August 2025
Design Development Updates

Upper Brook Street Masterplan (McLaren / Kadans)

UBS-SRA-XX-XX-RP-A-00101

This document has been produced by Sheppard Robson and proposes minor changes to the approved Sci-Tech scheme located in Upper Brook Street, Manchester.

Eighth Floor
Consented Plan

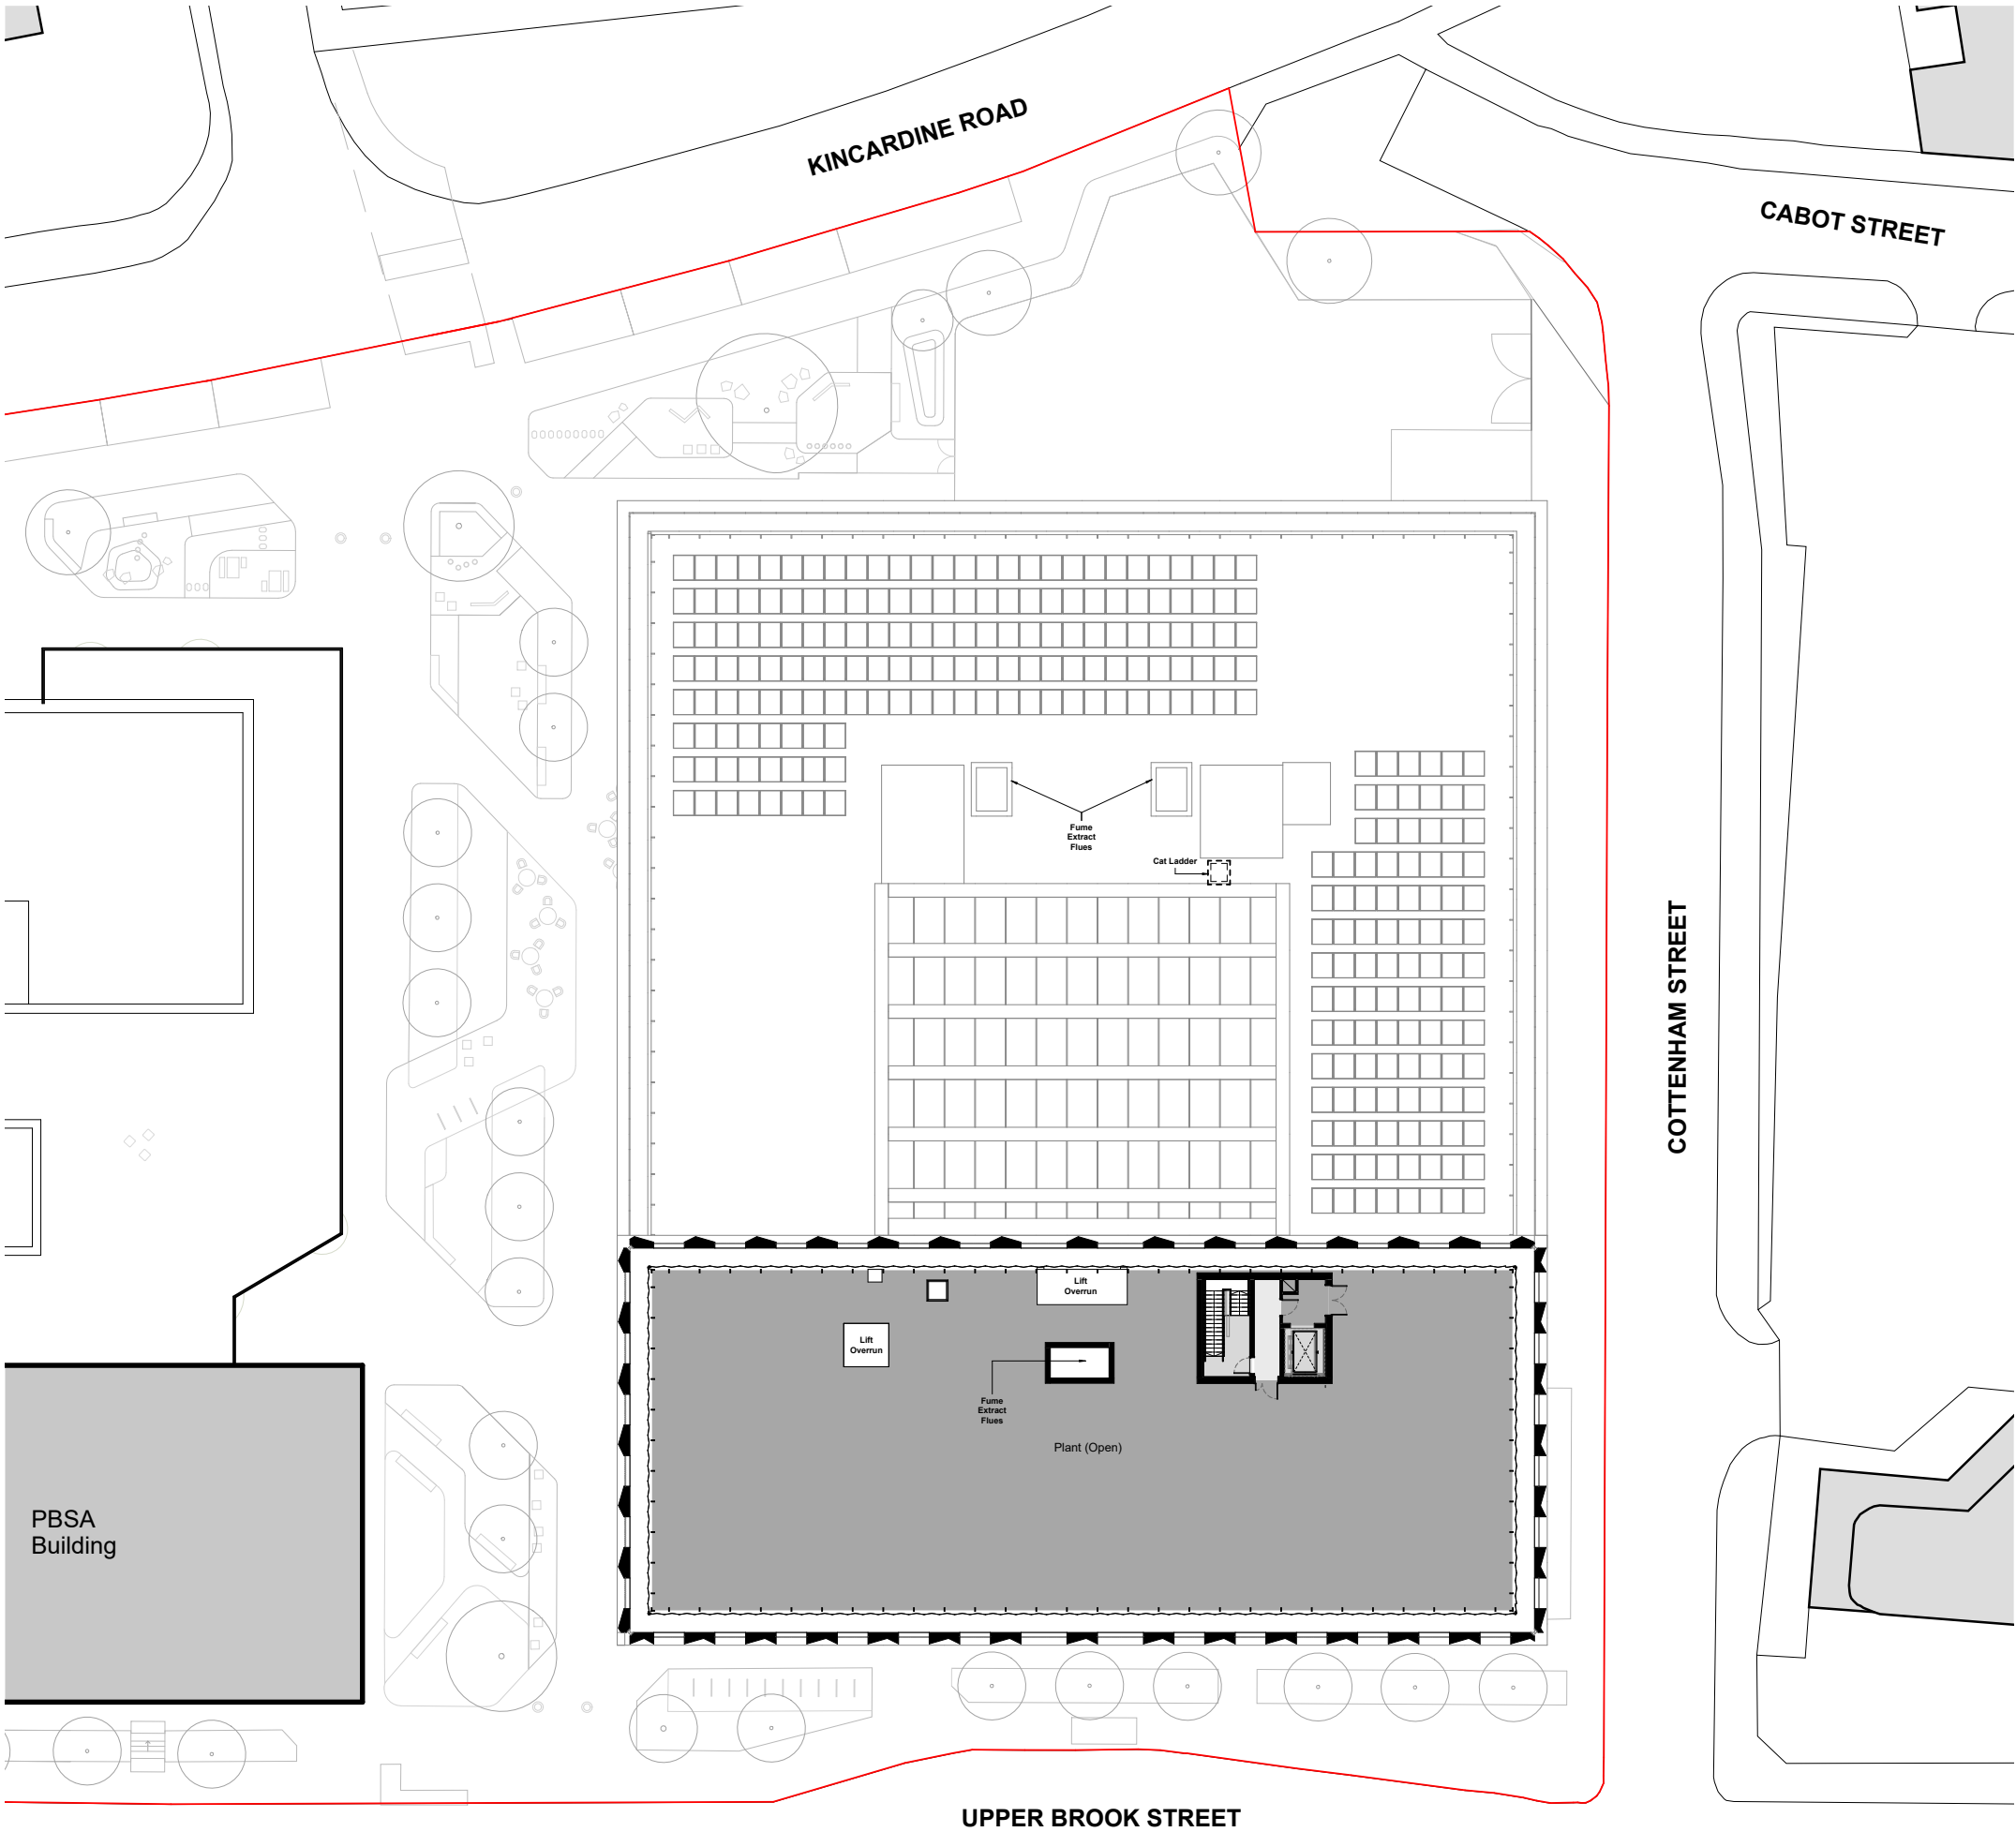
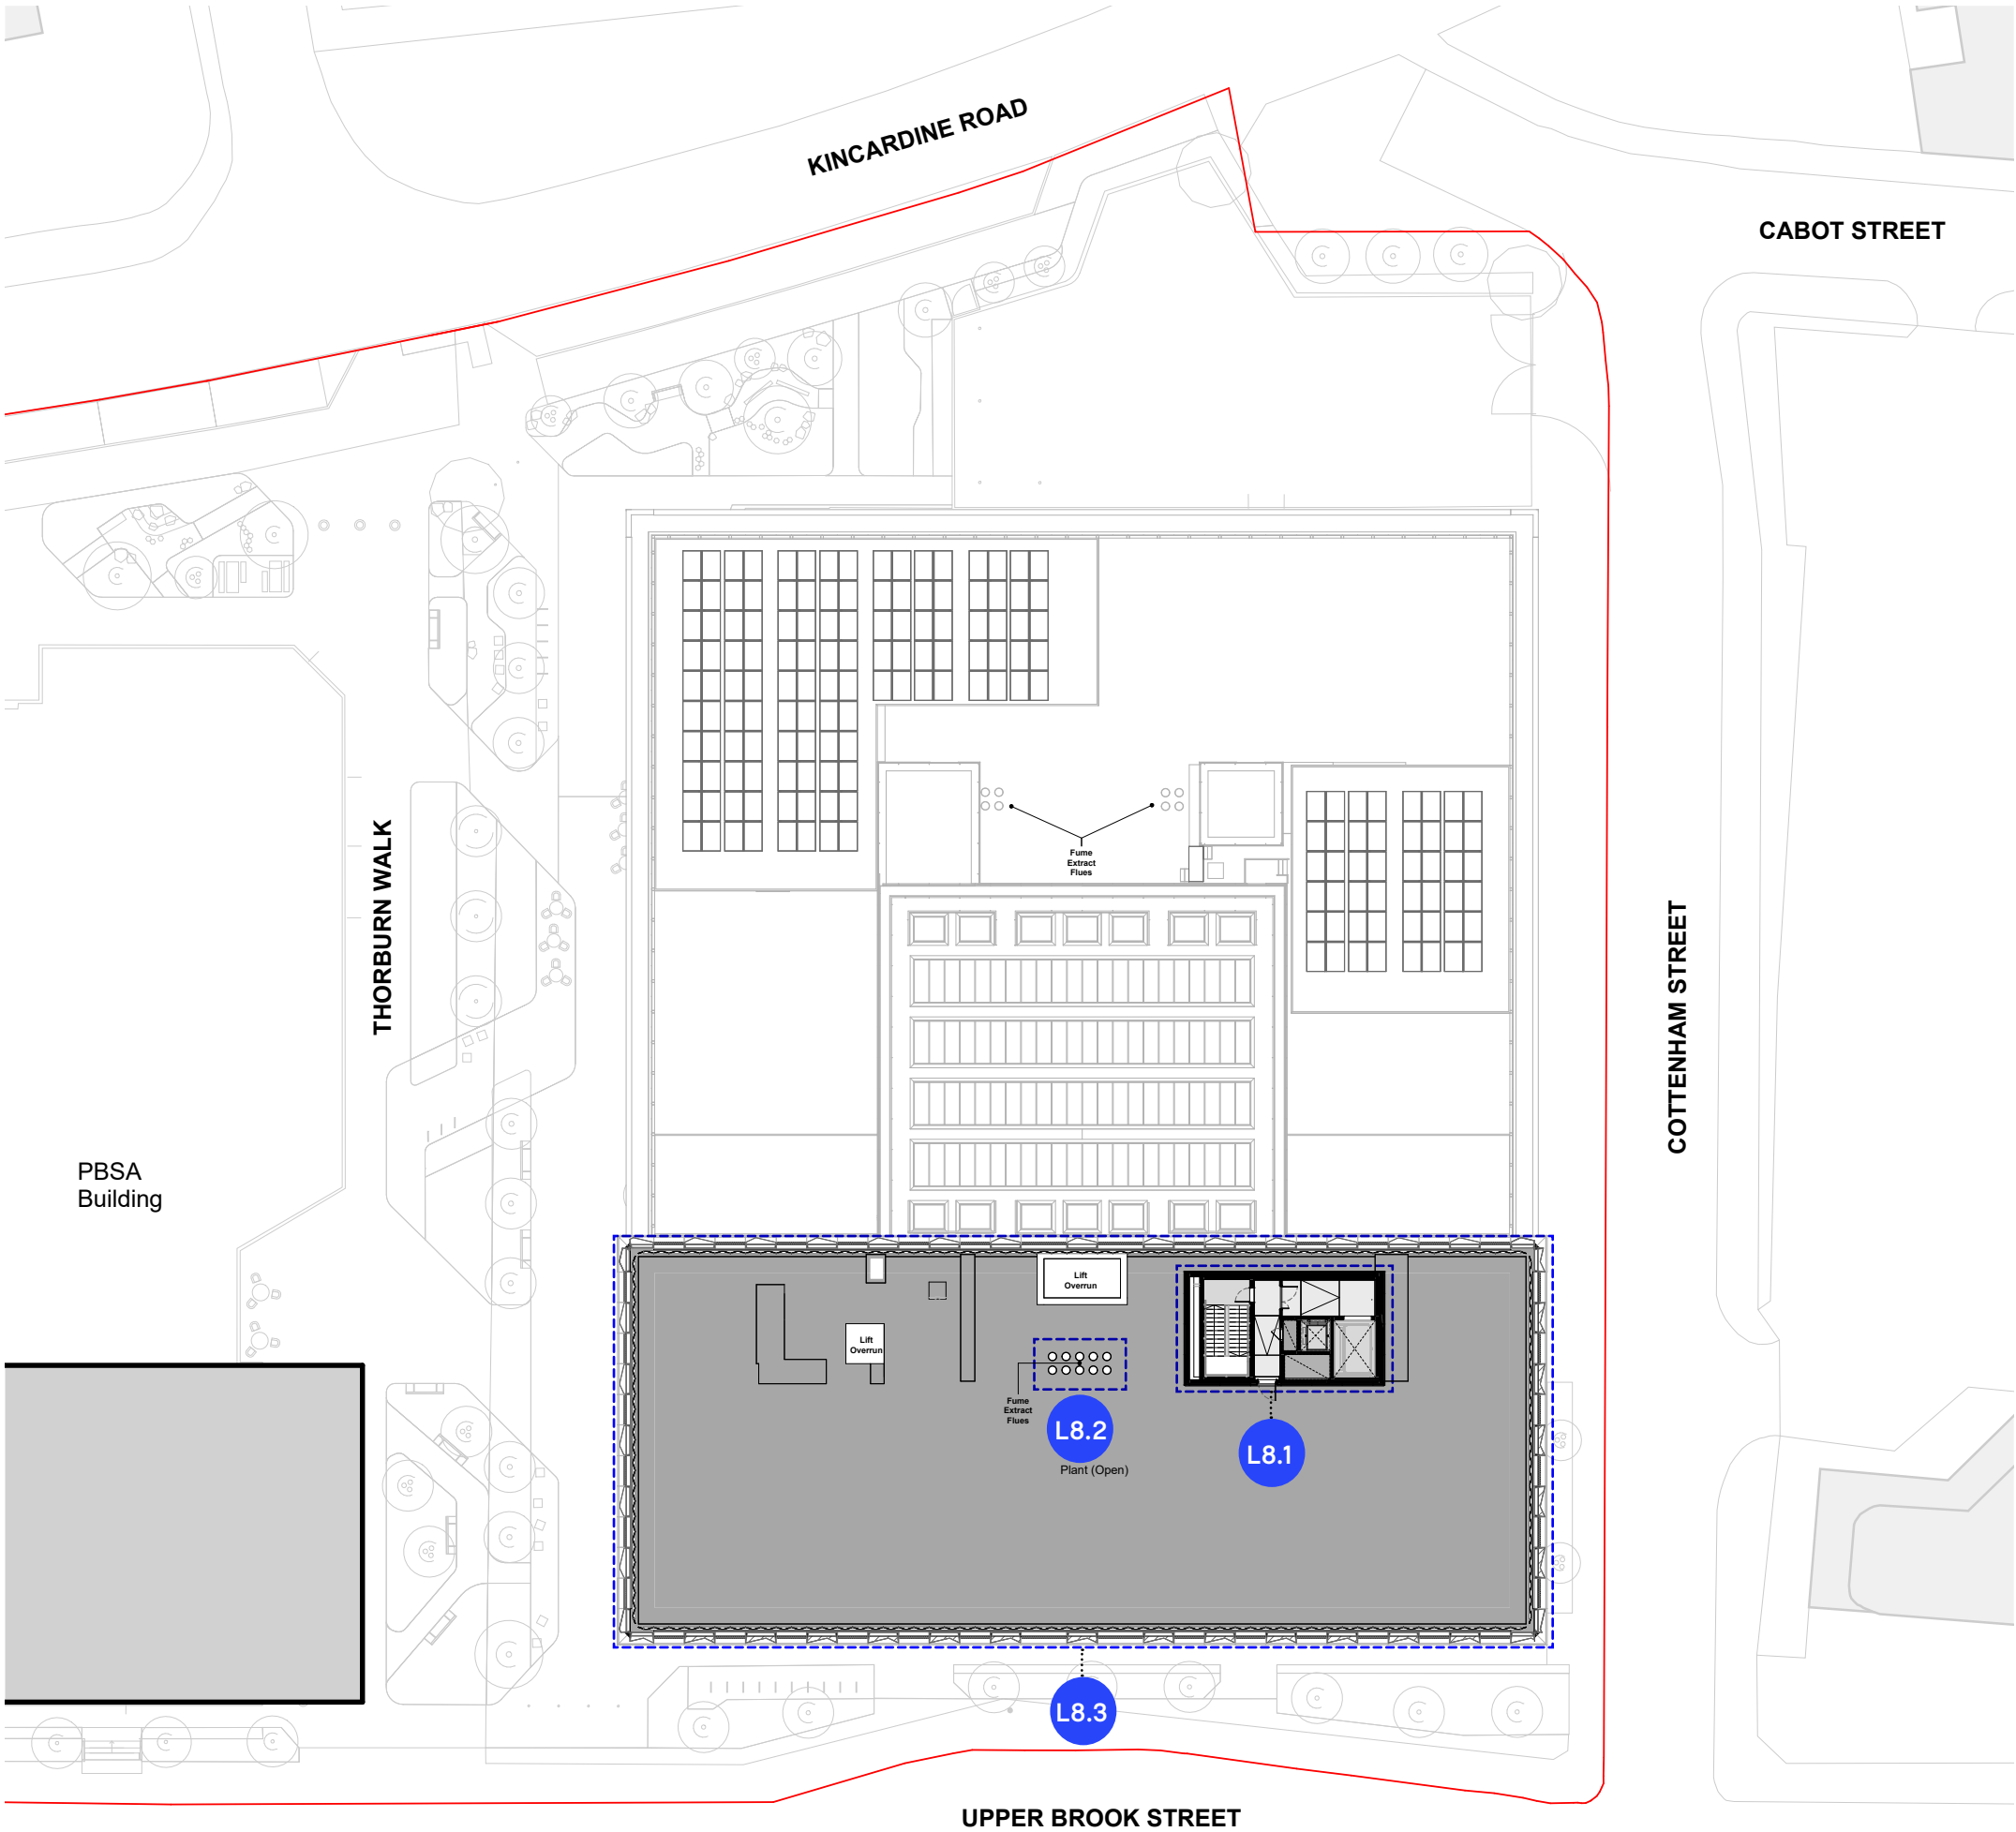
- L8.1** The core overrun footprint was slightly increased following cladding and structure coordination.
- L8.2** The future tenant flue zone was clarified, and flues have been included for illustrative purposes.
- L8.3** The plant screen location in the Level 08 roof was moved outwards to reduce the distance to the facade piers.

Change Code	Drawings Affected	Description	Design Development Justification
L8.1, L8.2	• UBS-SRA-ST-05-DR-A-02-508	• Core overrun extent increased	• Core overrun extent reviewed following cladding design development
	• UBS-SRA-ST-05-DR-A-02-509	• Future tenant flue zone clarified	• Following building services coordination, flue design and zone has been clarified, flues have been included for illustrative purposes.
	• UBS-SRA-ZZ-EN-DR-A-02-306		
	• UBS-SRA-ZZ-ES-DR-A--02-307		
	• UBS-SRA-ZZ-EE-DR-A-02-308		
	• UBS-SRA-ZZ-EW-DR-A-02-311		
	• UBS-SRA-ZZ-SE-DR-A-02-320		
	• UBS-SRA-ZZ-EE-DR-A-02-321		
L8.3	• UBS-SRA-ZZ-EE-DR-A-02-322		
	• UBS-SRA-ST-05-DR-A-02-508	• Plant screen location moved outwards	• Allows for more MEP roof space.
	• UBS SRA ST ES DR A 02-402		
	• UBS SRA ZZ SE DR A 02-321		
	• UBS SRA ZZ SN DR A 02-322

Eighth Floor Arkley Street View

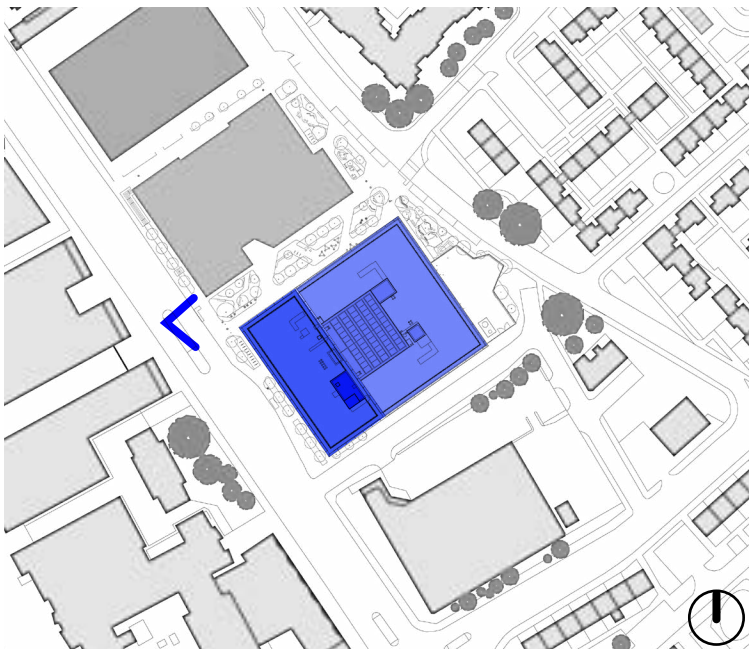
- L8.1 The core overrun footprint was slightly increased following cladding and structure coordination.
- L8.2 The future tenant flue zone was clarified, and flues have been included for illustrative purposes.
- L8.3 The plant screen location in the Level 08 roof was moved outwards to reduce the distance to the facade piers.
